Access Compliance Report

Public Rights-of-Way

(Curb Ramps)

Intersection ID: 15060	Main Street: DOROTHY_DR	Cross Street: IVERSON_WY	Location:	S
ADA ID: CA281CEF3685	Ramp Type: Directional1	Initial Pass/Fail: Fail	Overall Compliance: No	Severity Score: 1.25
Codes/Mitigation Info/Possible Solution		Field Measurements/Component Compliance

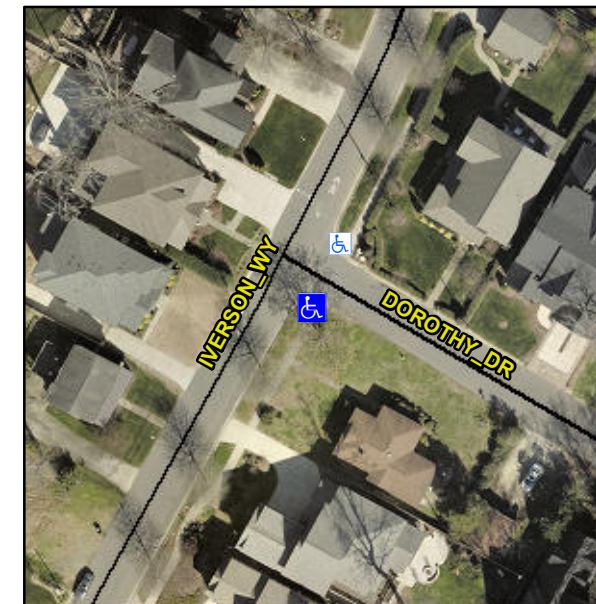
Surveyor Notes:

PONDING

PROW/ADA:

R304.5.3

Compliance	Description	Data	Compliance	Description	Data
N/A	Ramp Length (in)	127.0	N/A	Grade Break?	N/A
Yes	Ramp Width (in)	57.0	N/A	Grade Break Slope (%)	0.0
Yes	Ramp Slope (%)	8.0	N/A	Grade Break XSlope (%)	0.0
No	Ramp XSlope (%)	3.4			
N/A	Flare Type LT	N/A	N/A	Flare Type RT	N/A
N/A	Flare Slope LT (%)	N/A	N/A	Flare Slope RT (%)	0.0
N/A	Flare Traversable LT?	N/A	N/A	Flare Traversable RT?	N/A
N/A	Landing Length (in)	0.0	N/A	DWS Provided?	N/A
N/A	Landing Width (in)	0.0	N/A	DWS Contrast?	N/A
N/A	Landing Slope (%)	0.0	N/A	DWS Length (in)	N/A
N/A	Landing X Slope (%)	0.0	N/A	DWS Full Width?	N/A
N/A	Landing Curb? (Y/N)	N/A	N/A	DWS Offset LT (in)	N/A
N/A	Shared Landing?	N/A	N/A	DWS Offset RT (in)	N/A
N/A	Gutter Ponding?	0.0	N/A	Gutter Slope (%)	N/A
N/A	Gutter Lip Ht (in)	0.0	N/A	Gutter X Slope (%)	N/A
N/A	Painted X Walk1?	No		Road Slope (%)	2.6
	X Walk 1 Direction	To NE		Road X Slope (%)	0.4
	X Walk 1 Width (in)	N/A		Clear Space?	N/A

Possible Solutions:

Remove & Replace Entire Ramp.
